KEYSTONE XL PIPELINE PROJECT

0514-SD-P4-362.0-362.6-S

KEYSTONE XL PIPELINE PROJECT PIPELINE ROUTE VARIATION FORM				
1	VARIATION TYPE: Refinement: <input type="text"/> Reroute: <input checked="" type="checkbox"/> Footprint: <input type="text"/> Design: <input type="text"/> Centerline: <input type="text"/> Pump Station: <input type="text"/> Valve Site: <input type="text"/> CAR: <input type="text"/>			
2	LOCATION: Sketch: <input type="text" value="Attached"/> Pictures: <input type="text" value="N/A"/> State: <input type="text" value="SD"/> County: <input type="text" value="Butte/Perkins"/> Quad Map: <input type="text" value="N/A"/> Township: <input type="text" value="014N"/> Range: <input type="text" value="(009E), 010E"/> Aerial Map: <input type="text" value="See attached map sheet"/> Section: <input type="text" value="(13), 18"/> Centerline: <input type="text" value="11/18/2012"/> MP: <input type="text" value="362.03"/> to <input type="text" value="362.59"/>

KEYSTONE XL PROJECT
PROPOSED ROUTE VARIATION

DWG: XL-30-P-9299-A-CLRV SHEET: 1 of 1

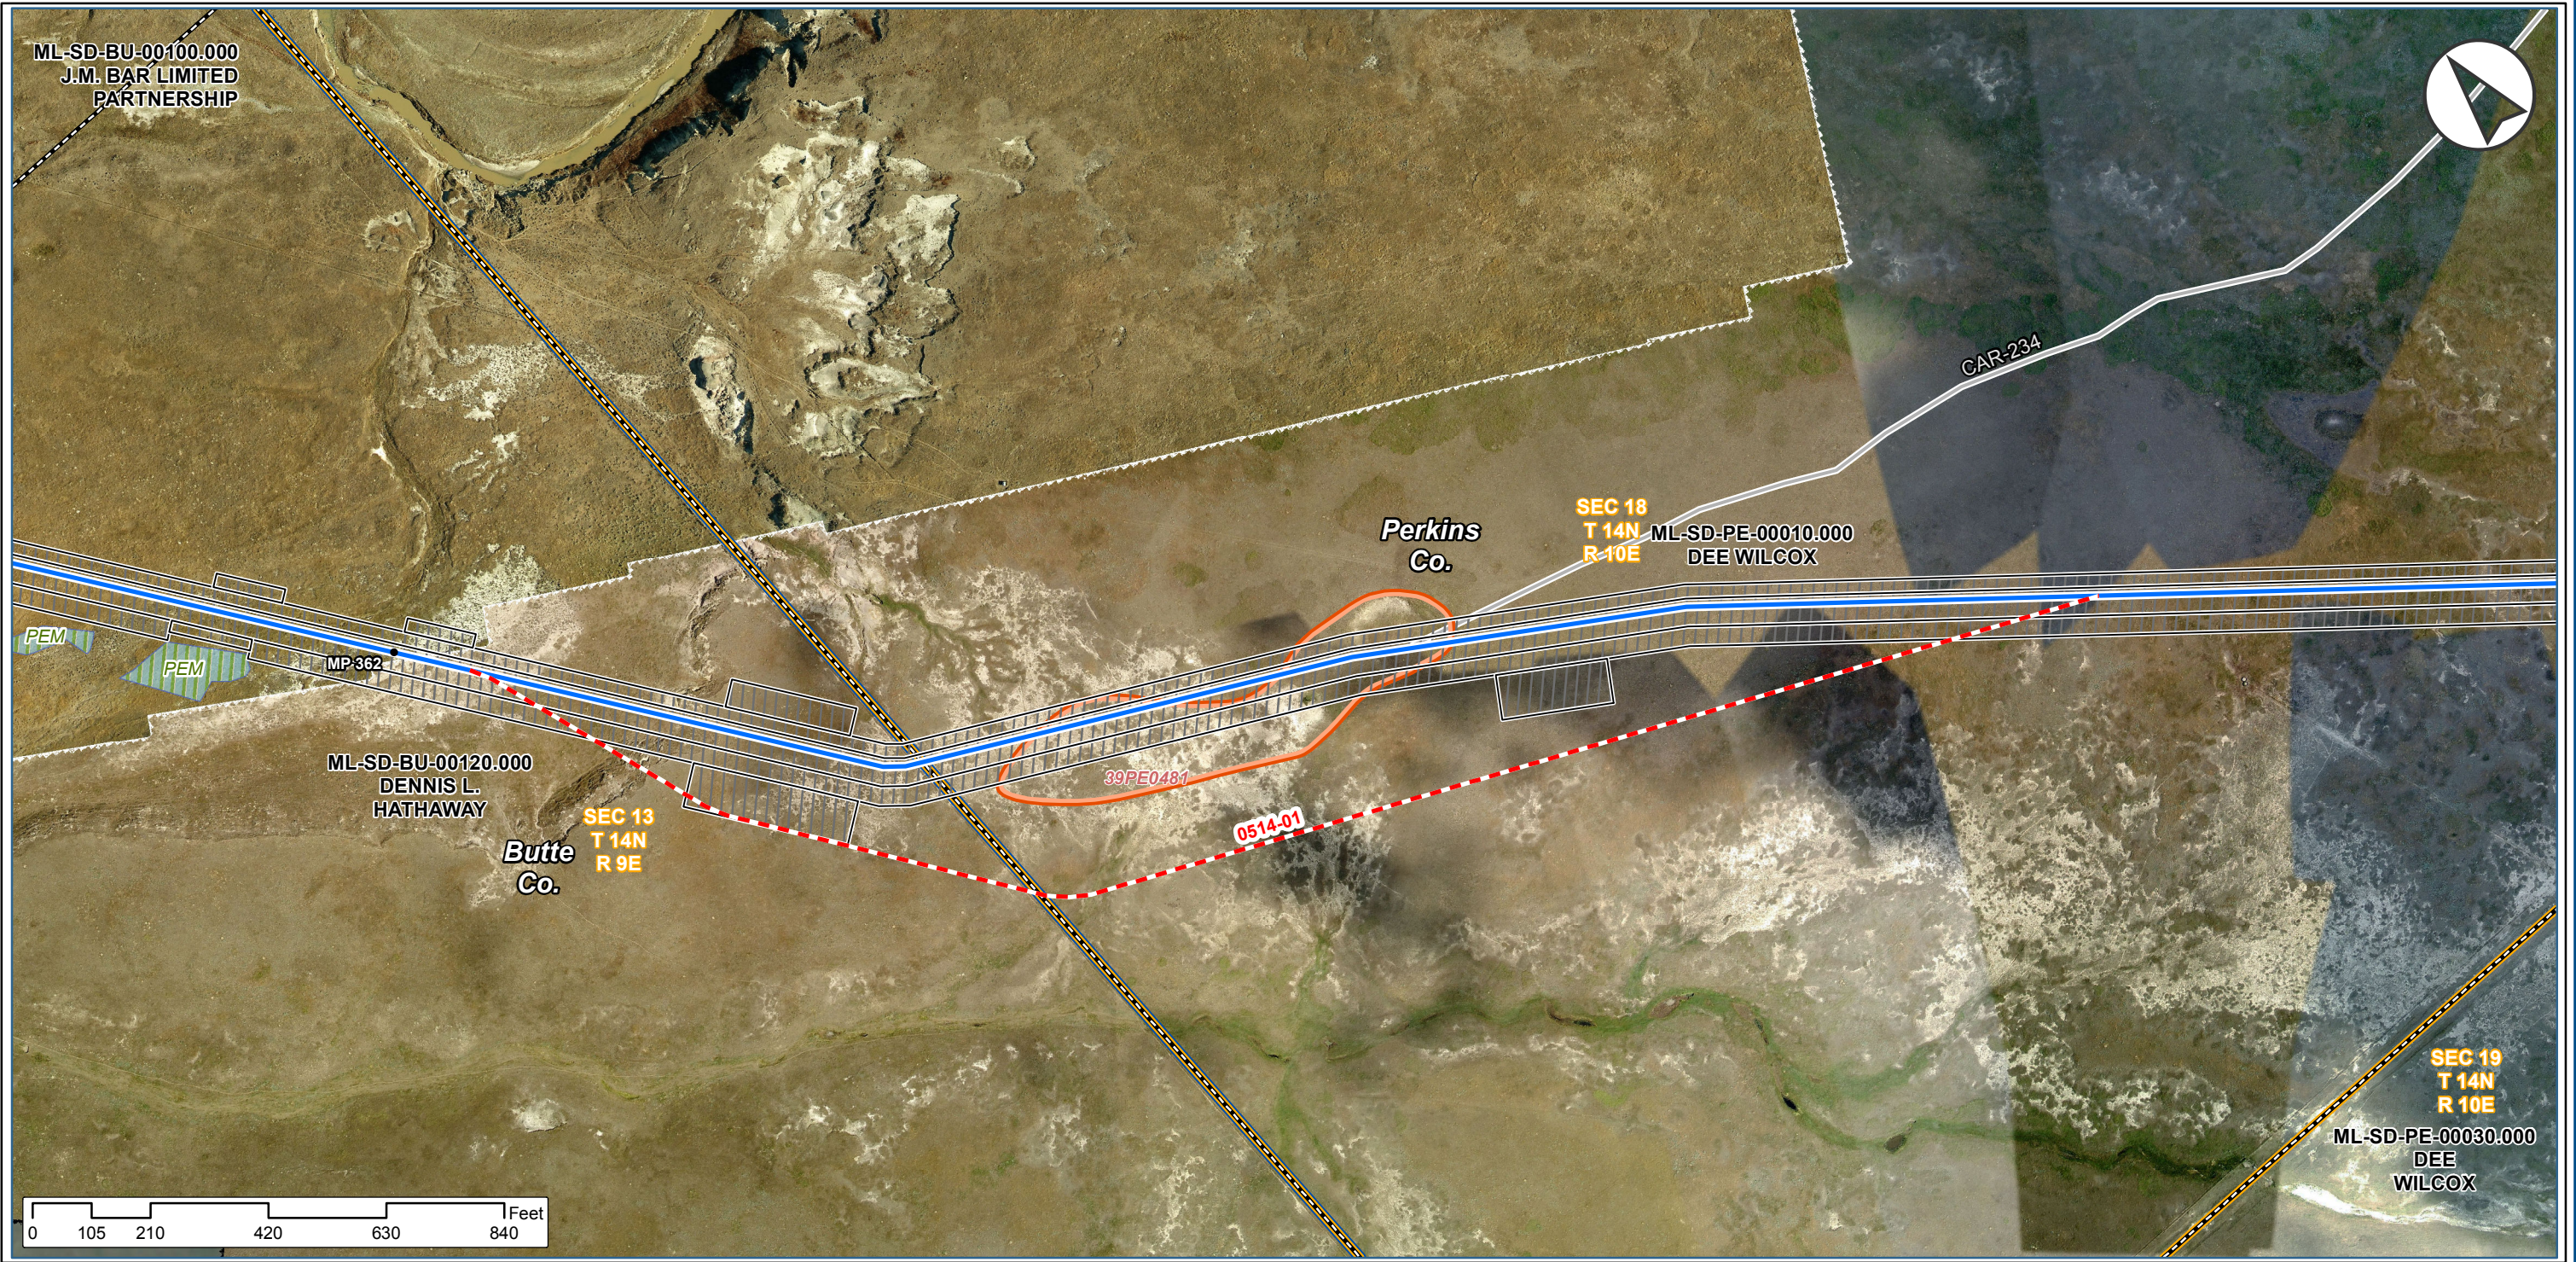
3	REASON FOR ROUTE VARIATION (Please include reason for route variation): The primary reason for this route variation is to avoid impacting eligible prehistoric cultural site (SN # 39PE0481 or C710PE001) by shifting the CL/workspaces southwest, thus avoiding the need for treatment/mitigation. This reroute is requested by Environmental and has been verified by field reconnaissance (civil survey).			
	DETAIL ROUTE VARIATION (Please describe route variation in detail): The proposed route variation begins near MP 362.0 and deviates ~8° to the west from the current CL for 40 ft. before shifting ~9° to the west and continuing for 446 ft. The proposed reroute, then shifts east for 40 ft, then shifts easterly and continues in this direction for ~583 ft. before rounding into an ~1,872 ft. stretch that reconnects to the CL near MP 362.6. 2 Tracts impacted: ML-SD-BU-00120.000 (Dennis Hathaway) ML-SD-PE-00010.000 (Dee Wilcox)

ADDITIONAL IMPACTS (Please include any additional impacts which may affect cost; crossings, induction bends, etc.): Additional costs are associated with environmental survey. Additionally, this proposed RV will impact CAR-234 (to be extended towards new proposed CL). Miscellaneous cost savings include: Treatment/mitigation (includes: Mitigation plan and approval by agencies, field work and report, etc) ~\$200,000-\$250,000 The reroute increases pipe length by 114 ft.			
	Is there an increase/decrease in the number of crossings? Yes <input type="text"/> No <input checked="" type="checkbox"/>			
	If yes, please list: <input type="text"/>			
	COST ANALYSIS (costs incurred or saved from the route variation)			
	Additional length of route realignment:	114 ft.	\$ 40,913.57	\$ 360/ft
	Additional length of side-hill construction:	<input type="text"/> ft.	\$ -	\$ 19/ft
	Additional length of wetland construction:	<input type="text"/> ft.	\$ -	\$ 195/ft
